SUBJECT: NuScale Power, LLC Response to NRC Request for Additional Information No. 394 (eRAI No. 9407) on the NuScale Design Certification Application

RAIO-0518-60110

NuScale Response to NRC Request for Additional Information eRAI No. 9407

Figure 15.2-7: Reactor Pressure Vessel Pressure - Peak RCS Pressure Case (15.2.1-15.2.3 LOEL-TT-LOCV)

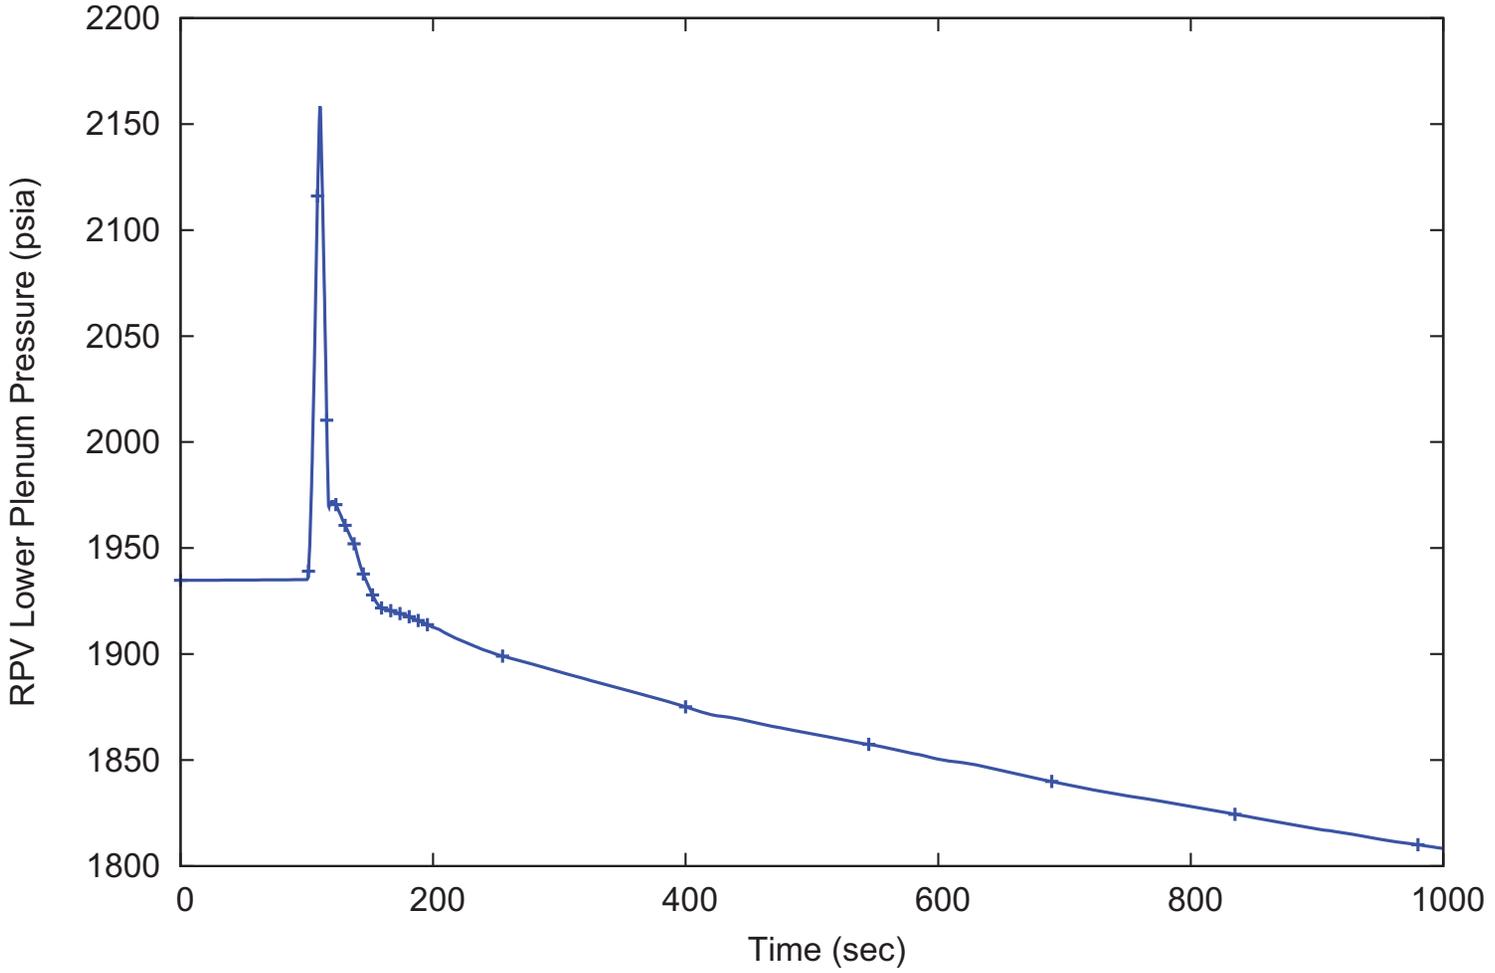
The staff notes that FSAR Figure 15.2-7 shows pressurizer pressure for the LOEL, TT, and LOCV maximum RCS pressure case, but the peak pressure shown in the figure is less than the maximum RCS pressure in FSAR Table 15.2-7 (2158 psia), presumably because the maximum RCS pressure occurs at a different location in the RCS. To allow the staff to verify the RCS pressure response for these events, please provide and add to the FSAR a new figure that shows the pressure response for the location of maximum RCS pressure for the LOEL, TT, and LOCV events.

The requested figure has been added to the FSAR to show reactor pressure vessel (RPV) lower plenum pressure for the limiting loss of external load (LOEL), turbine trip (TT) and loss of condenser vacuum (LOCV) reactor coolant system (RCS) pressure transient scenario.

FSAR Figure 15.2-7 has been revised as described in the response above and as shown in the markup provided in this response.

Figure 15.2-12: Net Reactivity - Peak RCS Pressure Case (15.2.4 MSIV Closure)

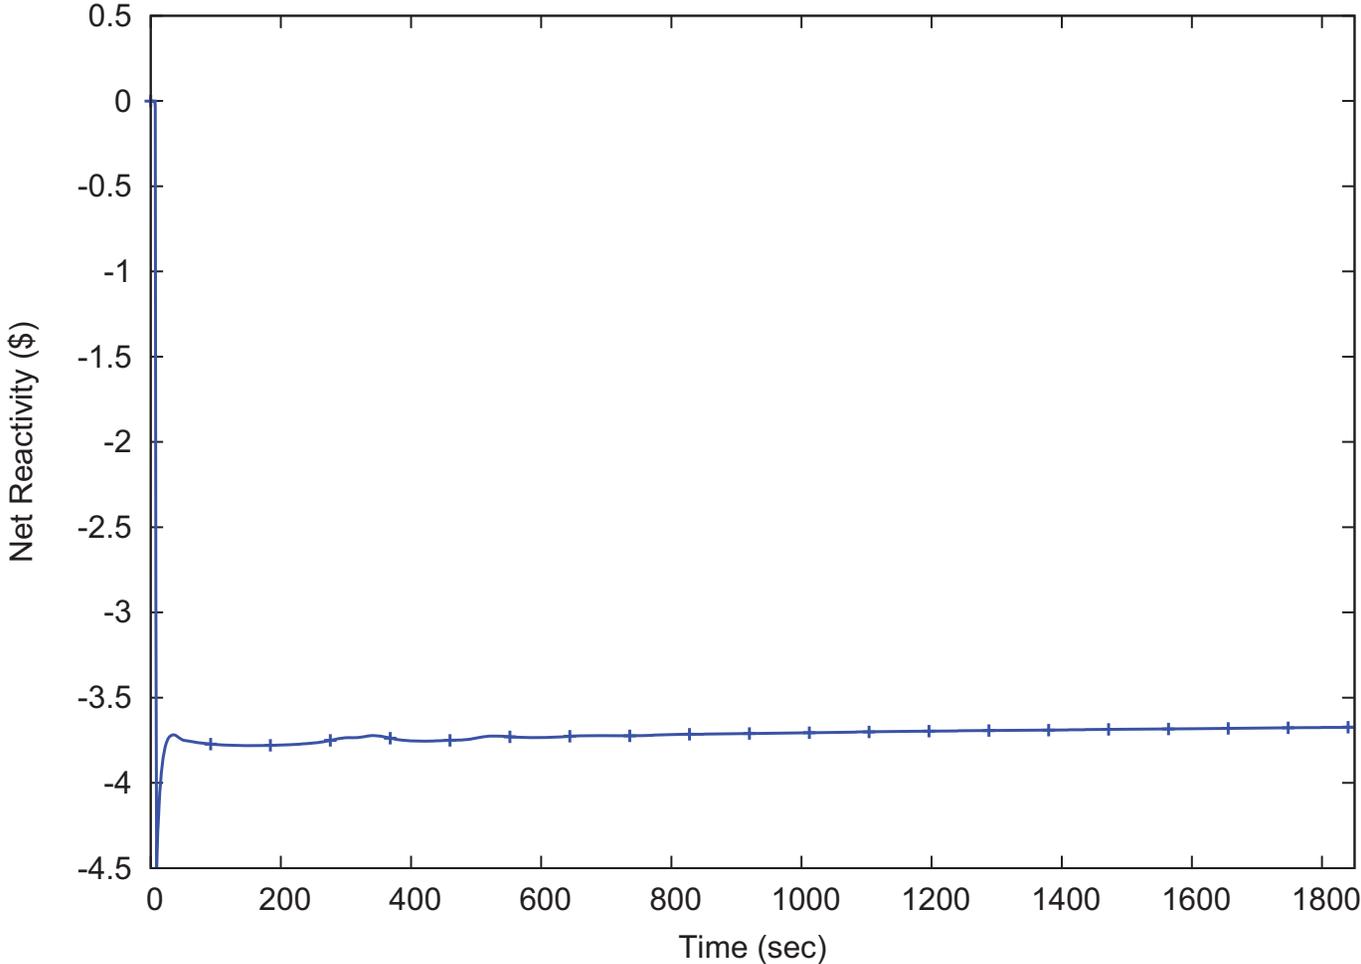
- FSAR Section 15.2.1.3.3, “Results,” refers to limiting MCHFR in Figure 5.2-9, but the correct figure number is 15.2-9.
- FSAR Sections 15.2.2.2 and 15.2.3.2, both titled “Sequence of Events and System Operation,” refer to more than one turbine stop valve (TSV). However, the staff notes that FSAR Chapter 10 indicates there is only one TSV per NPM.
- The title of Table 15.2-3 indicates it is a sequence of events table, but it is actually an initial conditions table.
- FSAR Tier 2, Figure 15.2-12 is titled “Net Reactivity – Peak RCS Pressure Case (15.2.4 MSIV Closure)” but appears to show RCS flow rate instead.

The FSAR Sections, Table and Figure noted above have been corrected. In addition, an editorial correction is made to the caption of Table 15.2-2.

FSAR Sections 15.2.1.3.3, 15.2.2.2, 15.2.3.2, Tables 15.2-2, 15.2-3 and Figure 15.2-12 have been revised as described in the response above and as shown in the markup provided in this response.
